# Access Compliance Report

## Public Rights-of-Way

| Intersection ID: 51610                  | Main Street: LUMSDEN_RD | Cross Street: MASTERTON_RD              | Location: E            |
| ADA ID: 3891B64185E1                    | Ramp Type: PerpDiag     | Initial Pass/Fail: Fail                 | Overall Compliance: No |

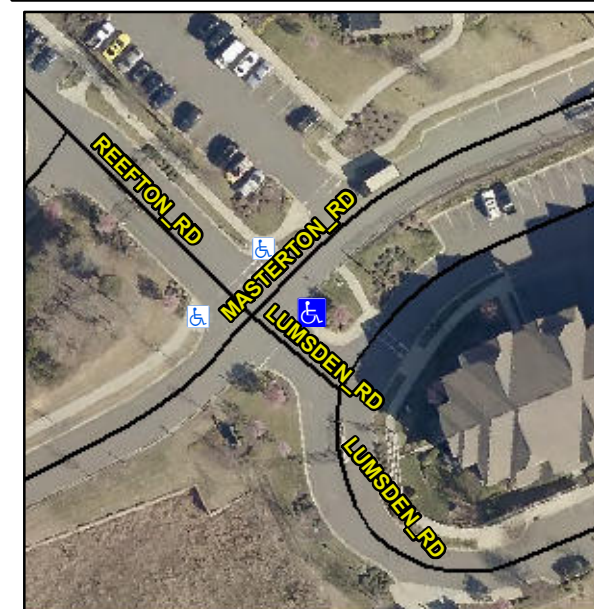
Possible Solutions:

**Remove & Replace Curb Ramp With Two New Directional Ramps or Equivalent.**

PROW/ADA:

**R304.5.3**

| Compliance | Description           | Data  | Compliance | Description                 | Data  |
|------------|-----------------------|-------|------------|-----------------------------|-------|
| Yes        | Ramp Width (in)       | 62.0  | No         | Ramp XSlope (%)             | 15.0  |
